PRESENTATION ON EA REVIEW

ENVIROSPHERE COMPANY
SHANNON & WILSON, INC.
COOPER CONSULTANTS, INC.

MARCH 8, 1985

This critique of the U.S. Department of Energy's Draft Environmental Assessment for the reference repository location at the Hanford Site has been conducted on the basis of technical merit and strict compliance with the USDOE General Siting Guidelines, without bias for or against the Hanford alternative. The guidelines explicitly call for assumptions conservative enough to underestimate the potential for a site to meet qualifying conditions (10 CFR 960.3-1-4-2). Most of our comments focus on the degree of conservatism underlying USDOE's conclusions.

Figure 3-37. Alternative concepts for ground-water movement based on anisotropy contrasts and hypothetical structures (after Gephart et al., 1983).

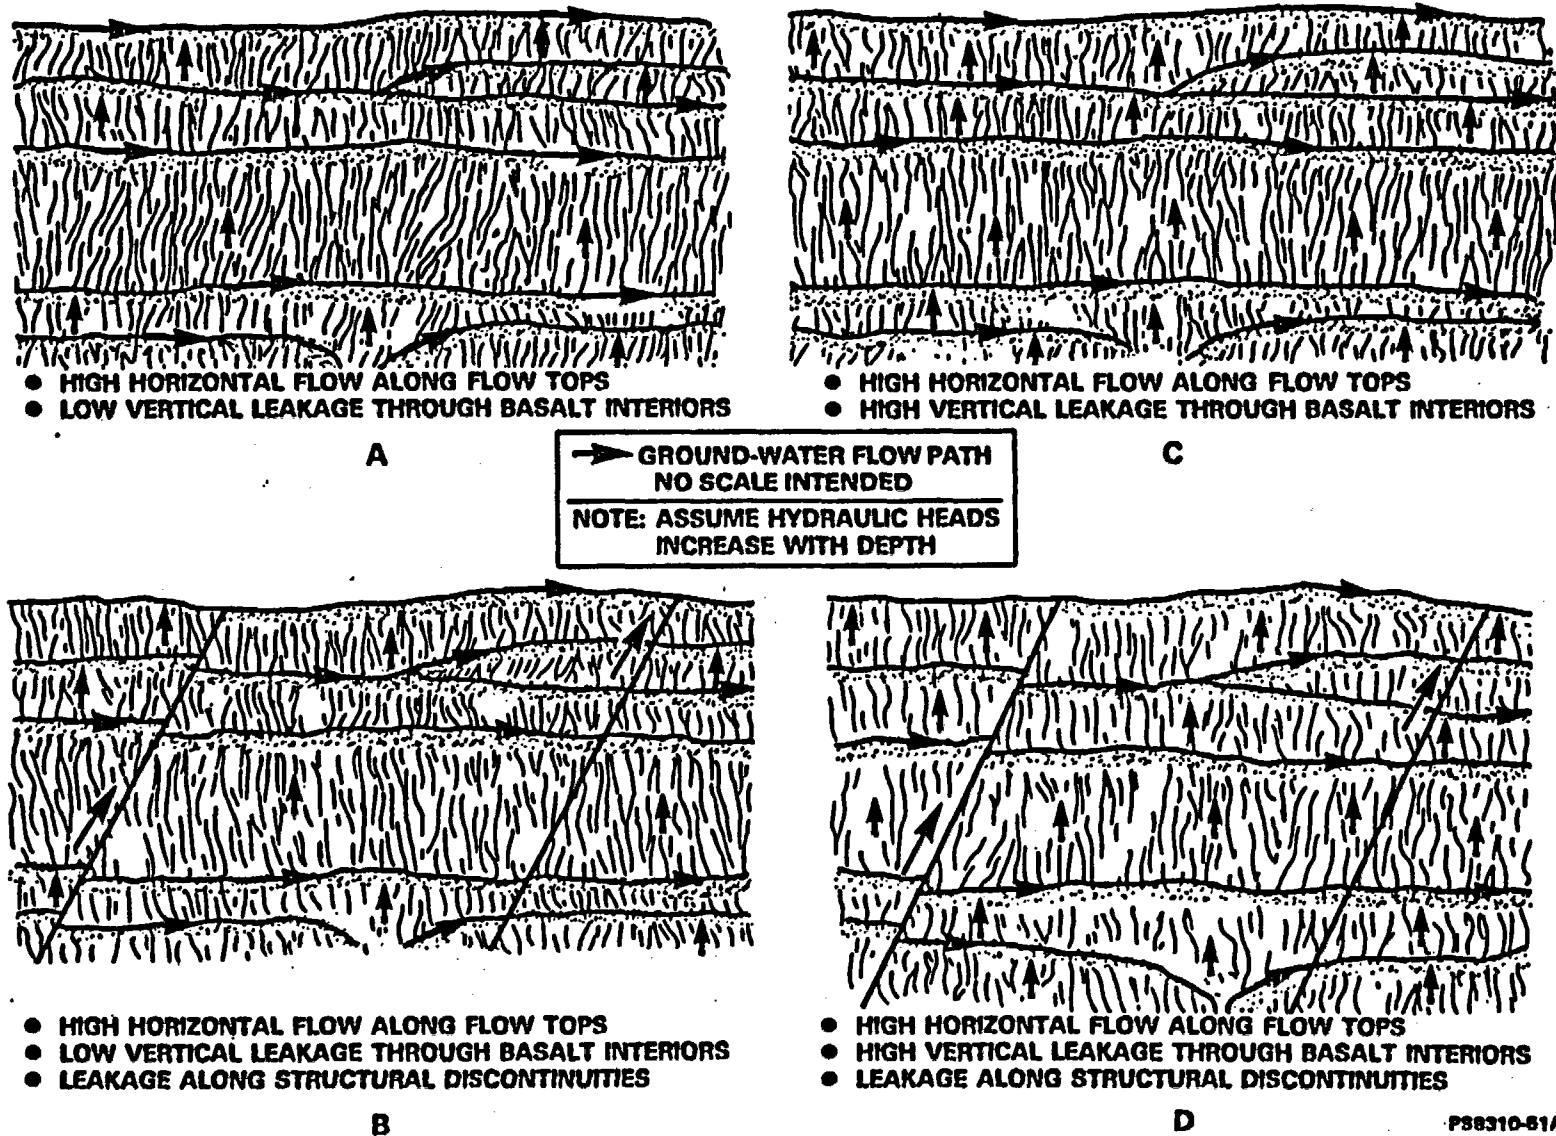
- MAJOR POTENTIAL LIMITATION TO POSTCLOSURE PERFORMANCE
- UNCERTAINTY OF GROUNDWATER DATA BASE, DEFENSIBLE EVALUATION NOT CURRENTLY POSSIBLE. }
- EVALUATIONS NECESSARY INCLUDE:

E) ZONES OF HIGH VERTICAL PERMEABILITY

- REEVALUATE USING ASSUMPTIONS THAT DO NOT OVERESTIMATE ABILITY TO MEET GUIDELINES

Figure 6-23. Conceptual model of ground-water flow paths used in site subsystem performance analysis (no scale).

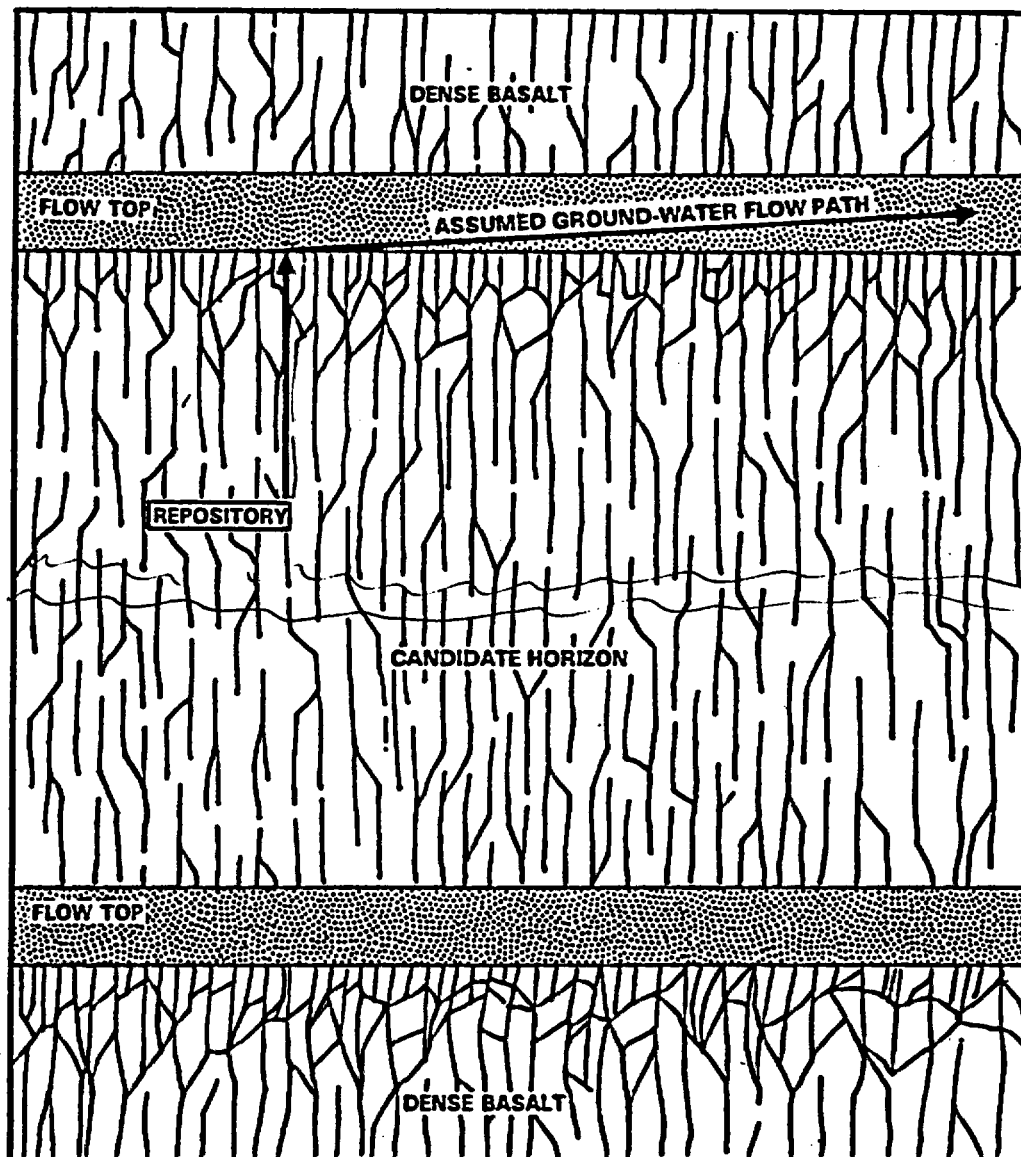
B) REGIONAL GROUNDWATER MODELING

Figure 3-36. Hypothetical composite cross section of possible geologic features in a layered basalt sequence (after Gephart et al., 1983).

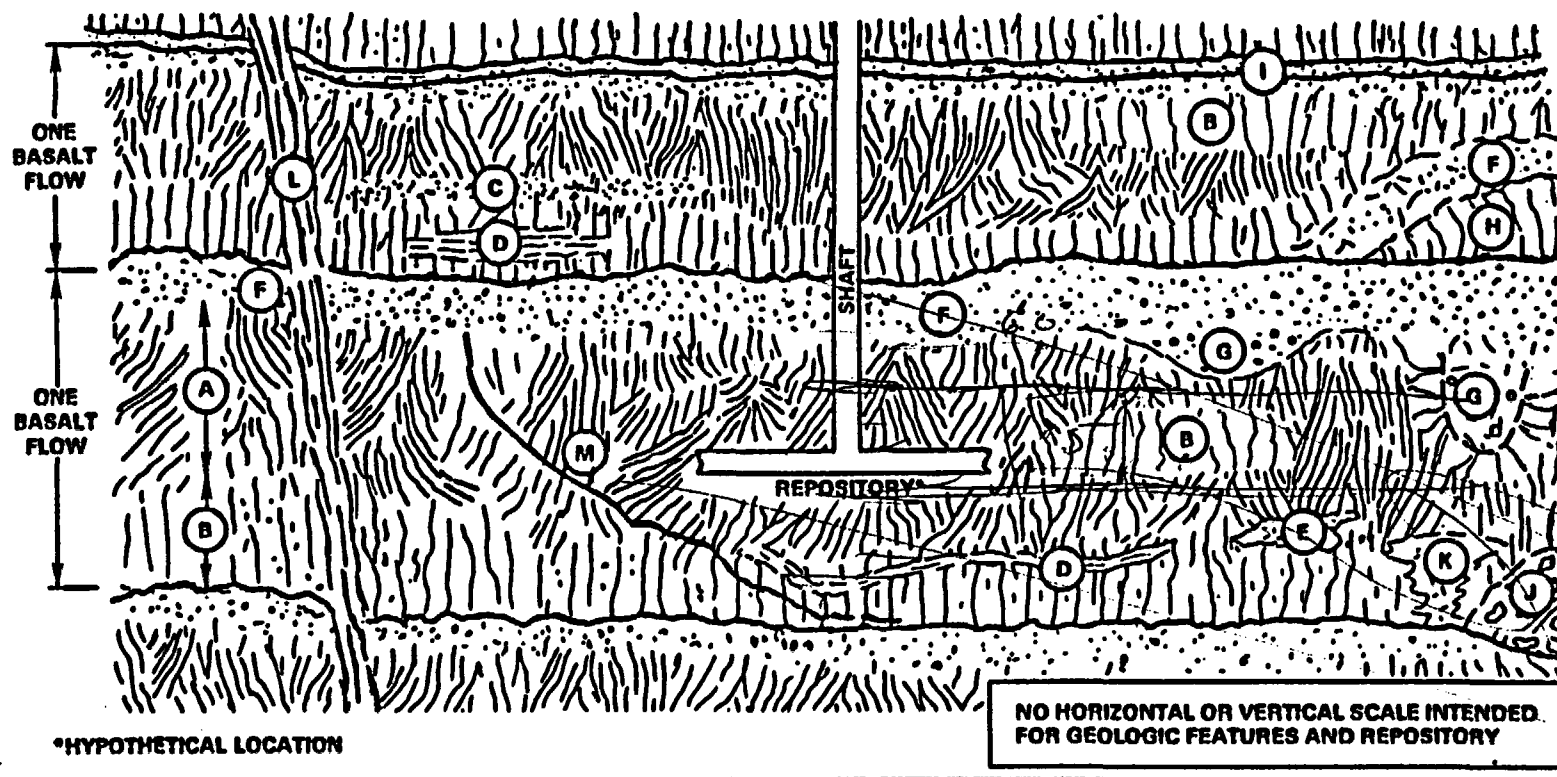
- REEVALUATE UNDERGROUND CONSTRUCTION COSTS
CONSIDERING UNCERTAINTIES
 - (1) IN SITU STRESS
 - (2) ANOMALIES
 - (3) GROUNDWATER INFLOW
- CHARACTER AND UNPREDICTABILITY OF INTERNAL STRUCTURES AND ANOMALIES *see next page*
- DEFENSE WASTE INCREASES CHANCES OF ENCOUNTERING GEOLOGIC ANOMALIES
- SHAFT DRILLING WOULD BE DEVELOPMENTAL
- CONTINGENCY PLANS FOR INCOMPLETE SHAFT OR INADEQUATE SEALING
- RECONSIDER PLANS AND EFFECTS OF HIGH IN SITU STRESS ON SAFETY AND COST *State wants to look at costs.*

Figure 3-43. Major Pacific Northwest rail lines providing access to the Tri-Cities, Washington.

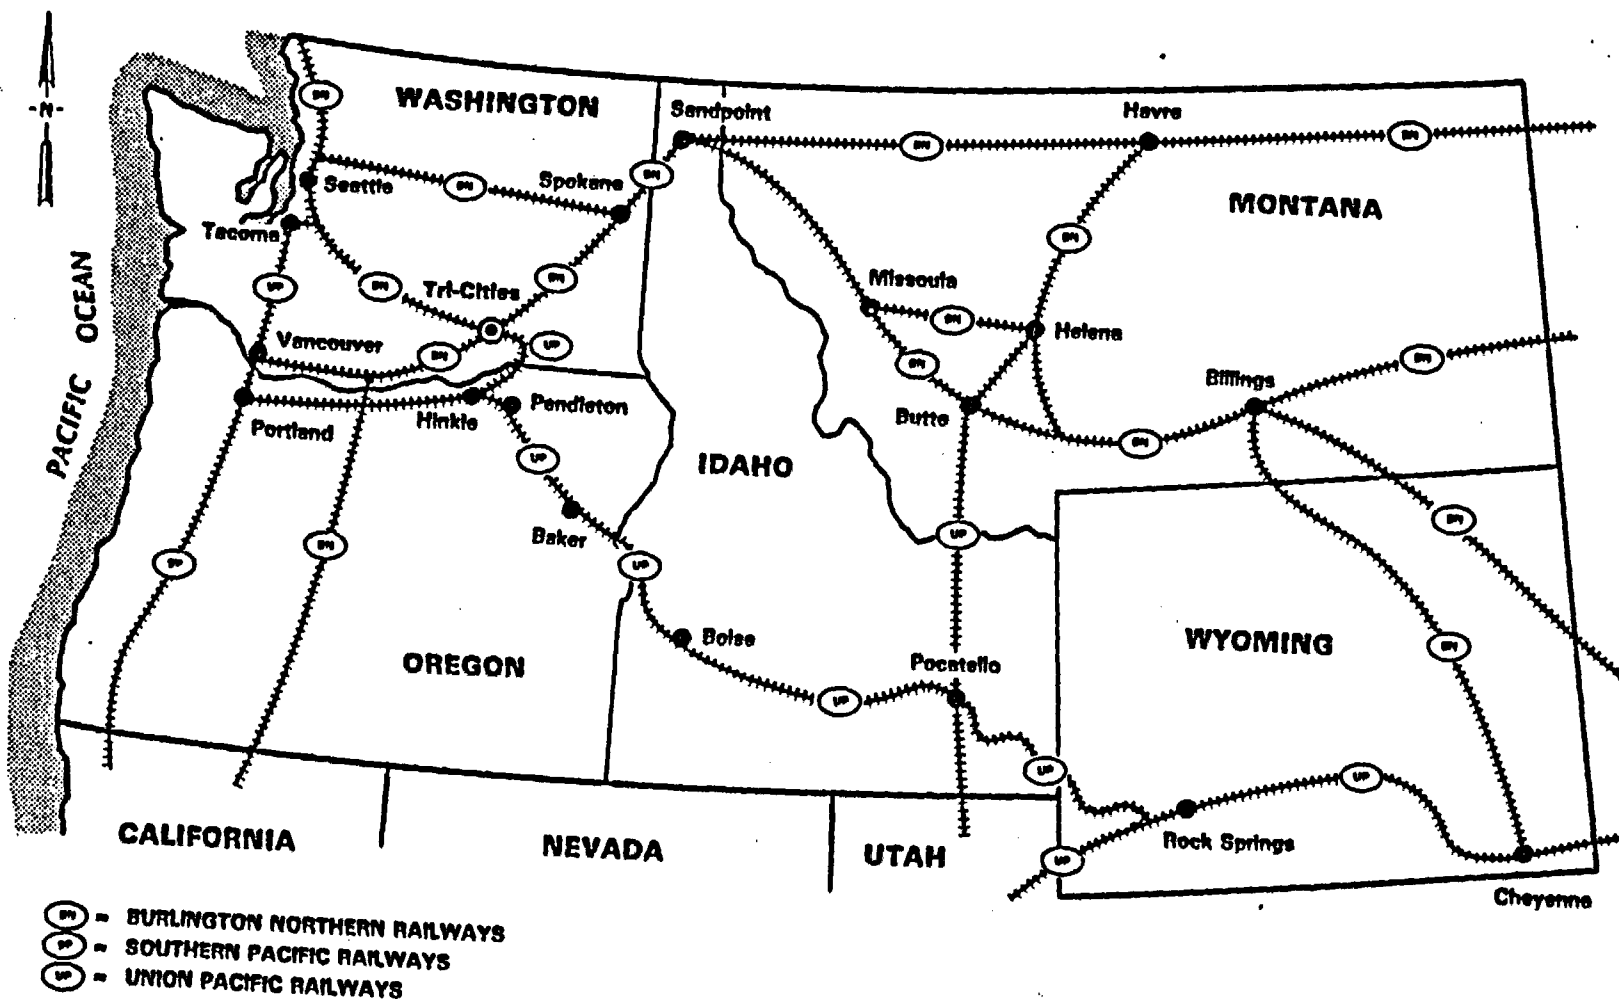
- DRAFT EA CONCENTRATES ON LOCAL RATHER THAN REGIONAL AND NATIONWIDE FACTORS.
- WHEN TOTAL SYSTEM IS CONSIDERED, EVALUATION IS BASED ON GENERIC UNIT RISK FACTORS; NOT ROUTE-SPECIFIC CONDITIONS.

- EVALUATION OF IMPACTS, COSTS, RISKS AND DISRUPTION POTENTIAL CONSTRAINED BY NARROW STUDY AREA BOUNDS. *look at manually exposed corridors*

Figure 2-26. Location of the reference repository location and alternate repository location.

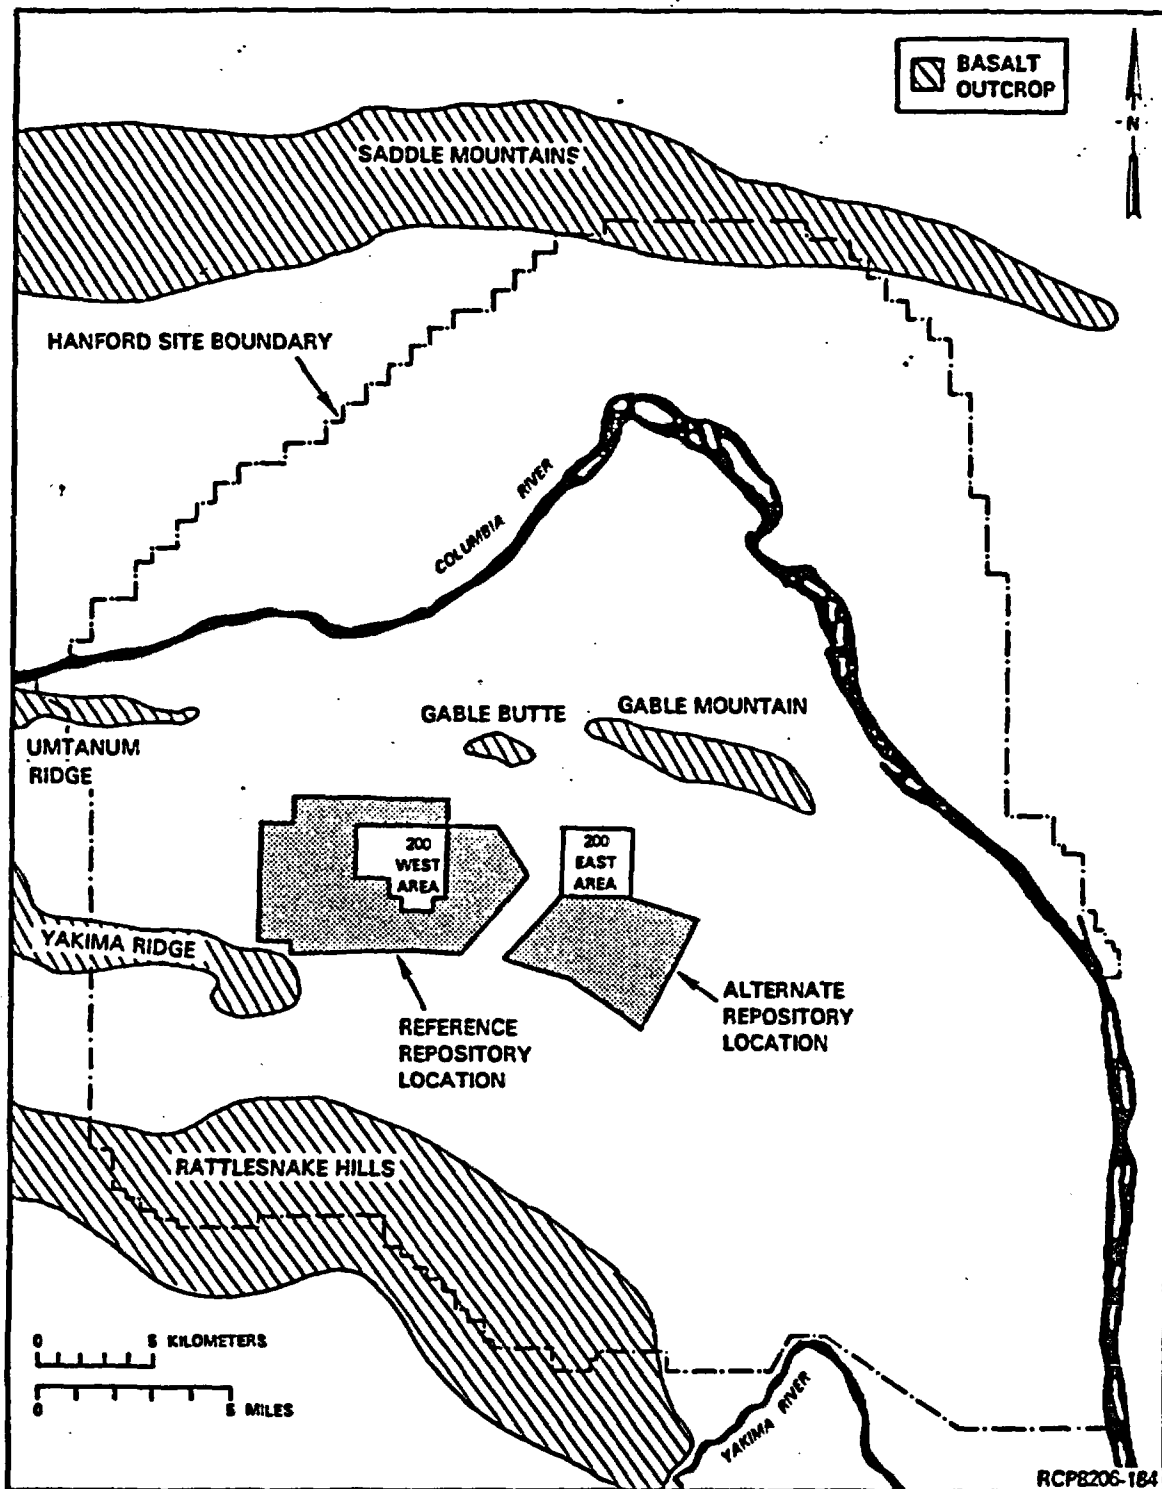
- RRL LOCATION BELOW 200-WEST AREA AND
ADJACENT TO 200-EAST AREA AND COMMERCIAL
LOW-LEVEL WASTE SITE
- PRESENCE OF HIGH-LEVEL WASTE STORAGE
TANKS, TRANSURANIC WASTES AND LOW-LEVEL
RADIOACTIVE WASTES
- IMPACT ON EFFECTIVE MONITORING OF
REPOSITORY PERFORMANCE, PARTICULARLY, <
ABILITY TO DIFFERENTIATE AMONG RELEASES -

*what about existing effects on wastes and
how ~~they~~ their release would be affected.*

Figure 3-36. Hypothetical composite cross section of possible geologic features in a layered basalt sequence (after Gephart et al., 1983).

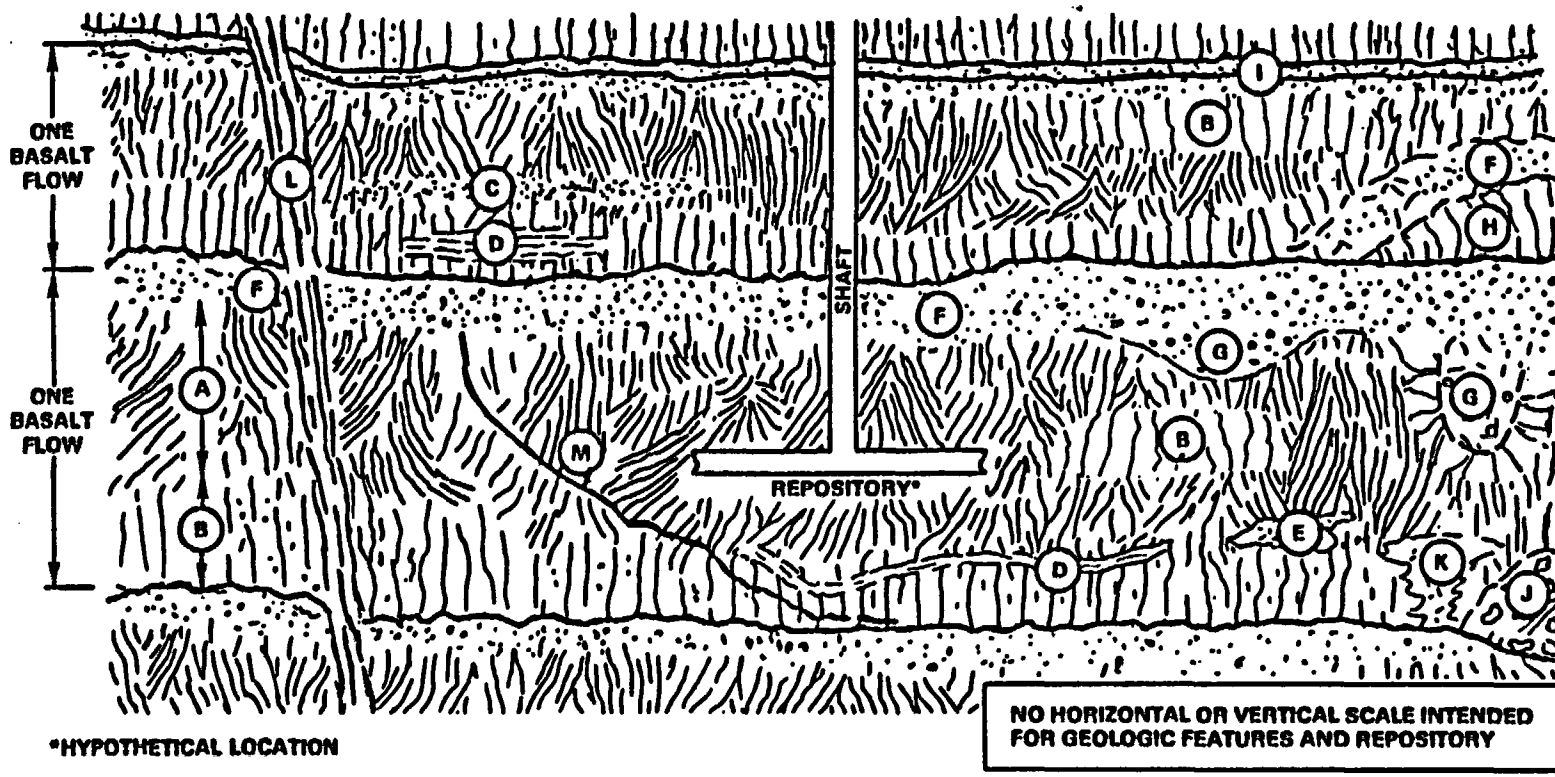
- COMMINGLING APPEARS LIKELY
- USDOE HAS ASSUMED (IN COMMINGLING STUDY) THAT REPOSITORY WOULD BE AUGMENTED TO ACCOMMODATE 10,000 MTHM OF DEFENSE WASTE
- THIS COULD REQUIRE UP TO 70% ADDITIONAL UNDERGROUND STORAGE (DEPENDING ON EFFECT OF LOWER HEAT CONTENT) } ? why.
- GREATER SPACE REQUIREMENTS INCREASE THE LIKELIHOOD OF ENCOUNTERING GEOLOGIC ANOMALIES, WITH POTENTIAL IMPACT ON CONSTRUCTABILITY AND COST
